**ADDENDUM #3**  
**E-BID #20220112**  
**Western Raw Water Main Construction Project**  
**Cost Work Sheet - Schedule "A"**

## Solicitation Addendum Form

Solicitation Number: 20220112	Solicitation Title: Western Raw Water Main Construction Project
Issuing Officer: Robyn Holder, CPPB	Solicitation Initially Posted to Internet: See DemandStar
eMail Address: rholder@cityofpsl.com	Telephone: 772-344-4293
Addendum Number: 2	Date: 11/16/2022

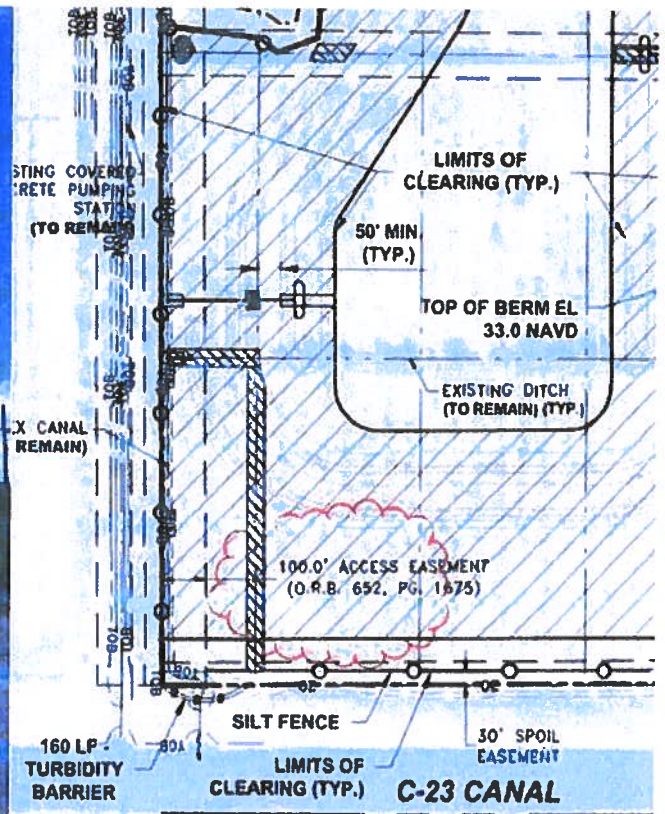
18. Question: There appears to be a large tower and electrical building in the southwest corner of the clearing limits in Area 5 that is not called out in the plans. Was this taken into account and what, if any, special conditions are required around this structure? (see below snip)

Response: **This is located within a different project.**
